Product Line In Vehicle Networking (PL IVN): Transfer of A-BCD1 TJA1050 High Speed CAN Transceiver from wafer fab DHAM to ICN8 with Bill Of Material (BOM) update

Date: April 19th 2013

Table 2: Product Marking

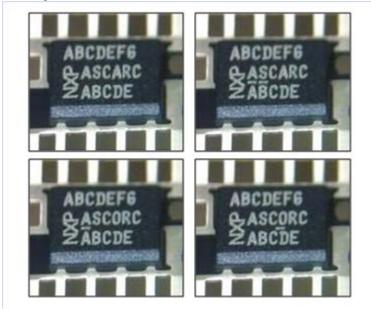
Marking of the TJA1050 product will be changed as follows:

n = assembly site APB, Thailand. The assembly site will not change. D = Dark Green mold compound.

In addition to the change in line B marking (6 characters instead of 5, as explained above), there will be additional dashes between line B and C. The amount and position of these dashes can vary, see the 4 pictures below for examples. These are generic examples, all lines will follow the above-mentioned marking format.
